Agency: U.S. NUCLEAR REGULATORY COMMISSION ADVISORY COMMITTEE ON REACTOR SAFEGUARDS Title: Meeting of the Advanced Pressurized Water reactor subcommittee

DATE: Wednesday, January 10, 1990 PAGES: 1 - 254

12 of the Westinghouse Evolutionary Light Water Reactor SP/90.

APWR REACTOR BUILDING

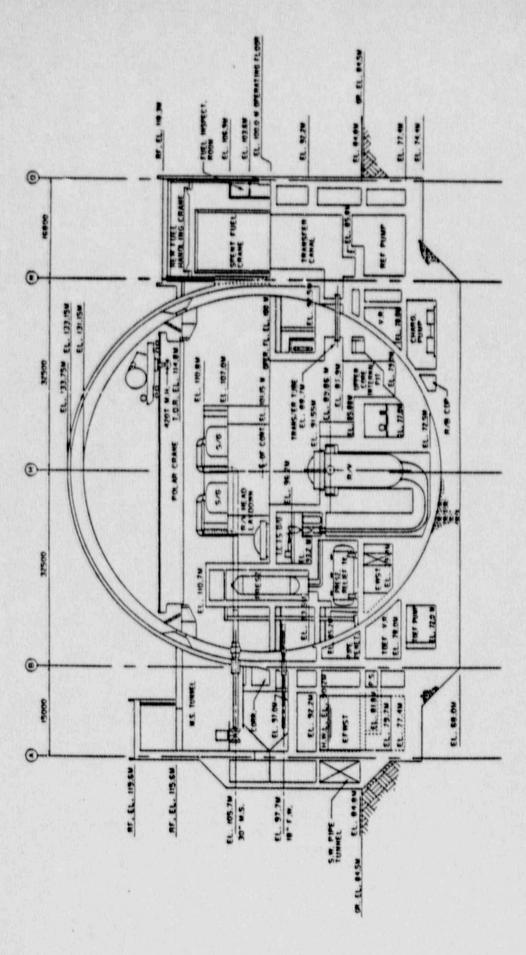
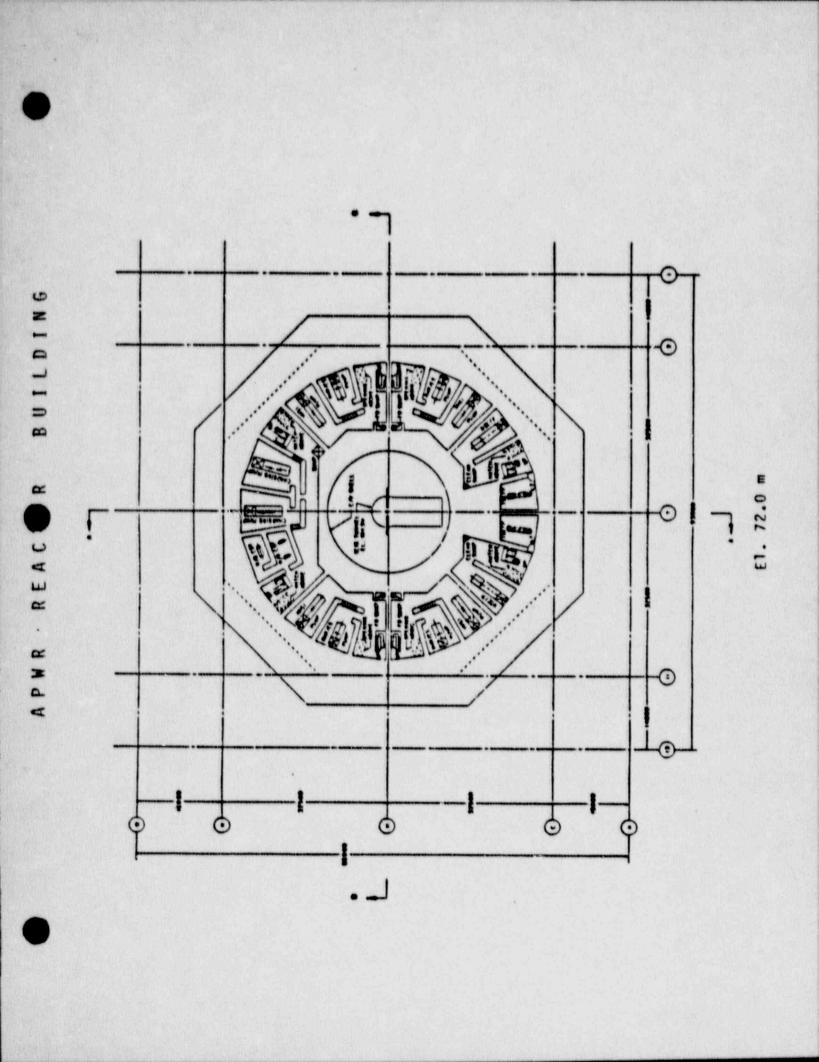
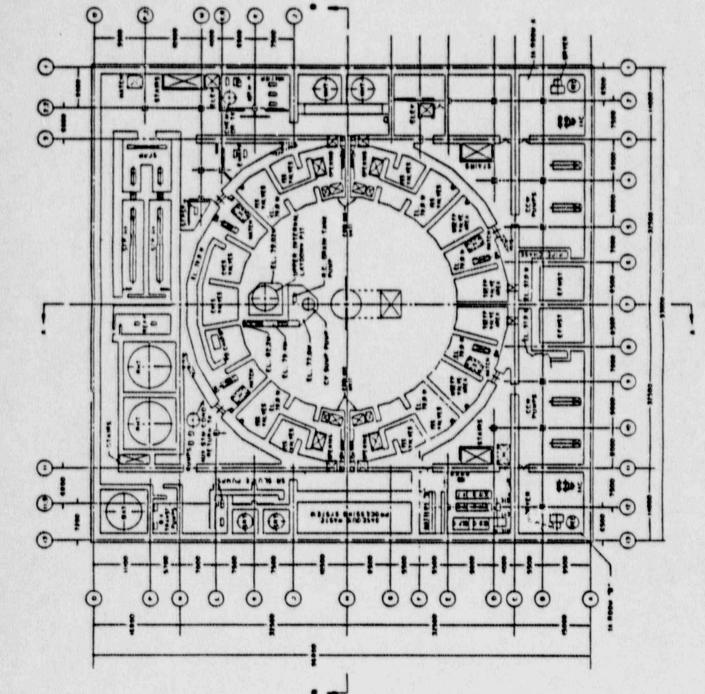
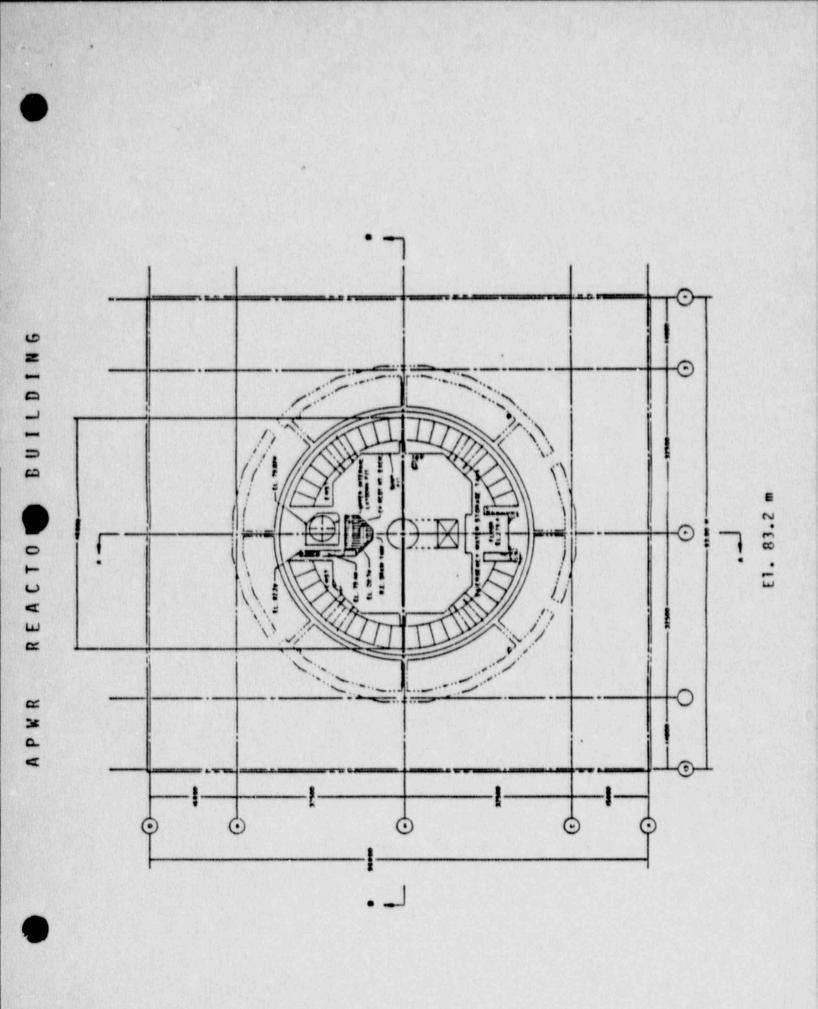
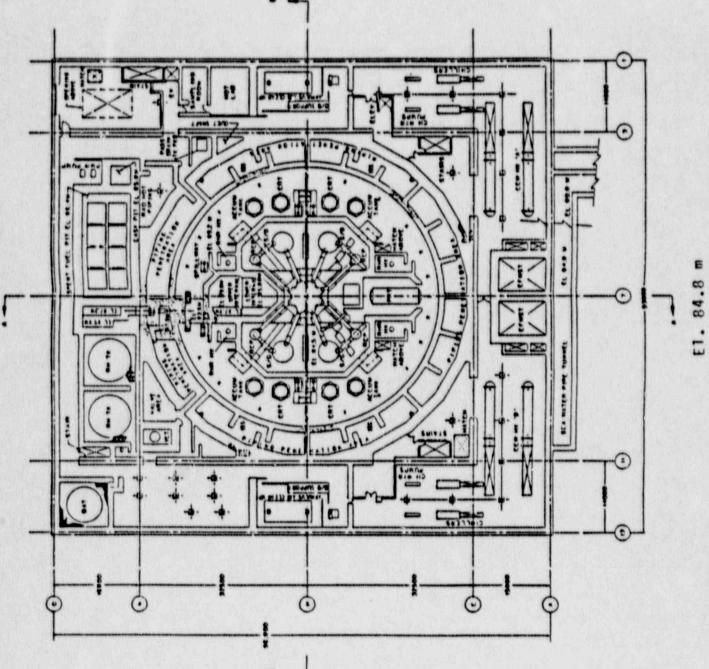
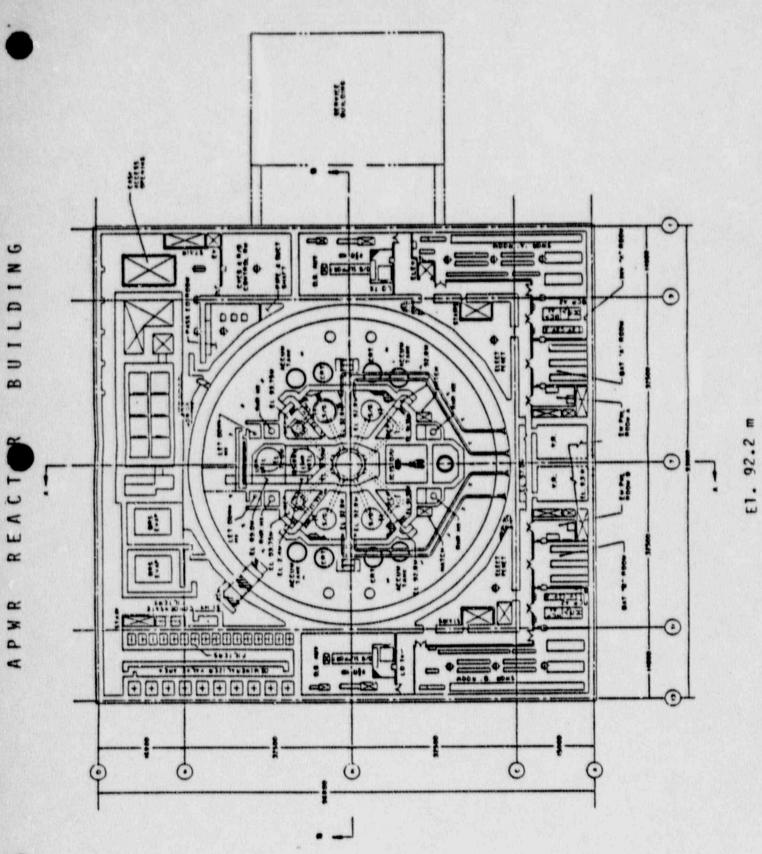
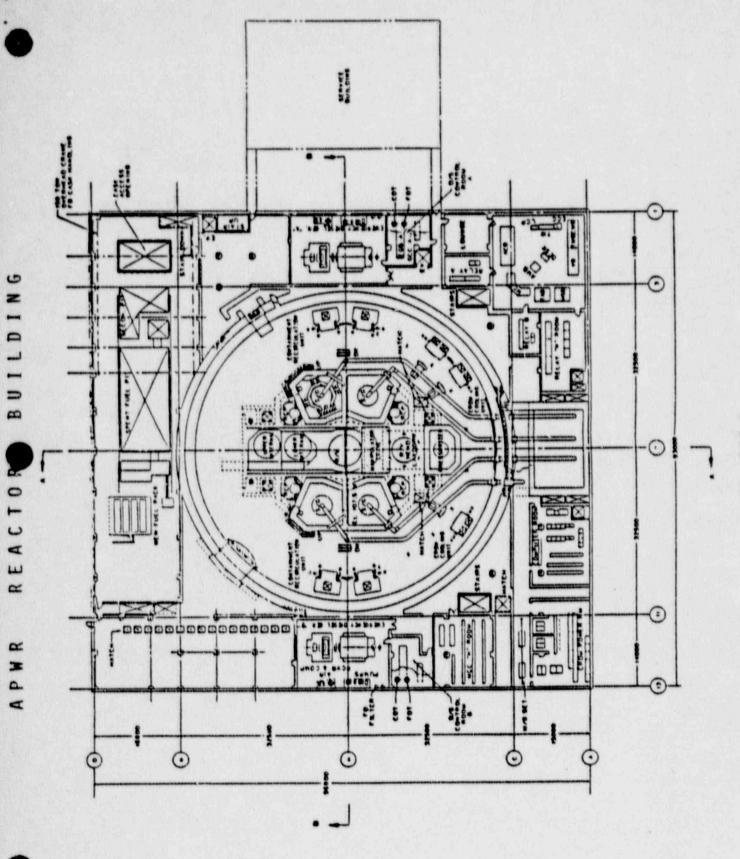
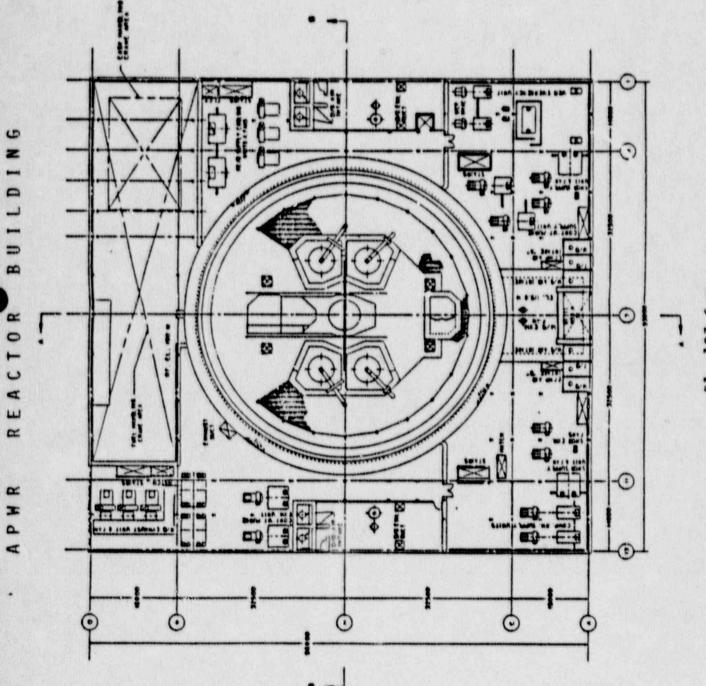
around that diesel engine and diesel fires are not incredible and explosions in that room are not incredible. So what is your philosophy on confining the effects of a loss of that diesel and its consequence to the plant on the control room which is so close? It's right down the hall.

7 MR. MICHELSON: I would really think you'd want to 8 look awfully close at how you ventilate that room, how you 9 control the fires in that room, what you do about the 10 explosions. I think there's a number of questions when you put 11 a control room that close to a diesel engine, which is not 12 traditionally done.

Again, if you're going to put a hazard that close to the control room, you've got to give it more attention than you would if it's parked off on the side of the building in its own concrete bunker, which a lot of plants do design that way.

19MR. MICHELSON: All right. I see them now. Okay.20So, the RELAY Room A is right next to the diesel21engines, just a wall between them. Right?22MR. VAN DE VENNE: Correct.23MR. MICHELSON: That's what it shows on my drawing.24Okay.

MR. VAN DE VENNE: At the design stage, there were a lot of discussions of removing the diesels from the integral mat for precisely that reason, because this is the way the Japanese do it in all their plants. We felt it was unusual and we would prefer to have them off the mat in their own separate buildings.

At the time, we decided, for reasons of commonality, that between the designs, that we really didn't want to change the design. But we may revisit that whole issue during the FDA stage.
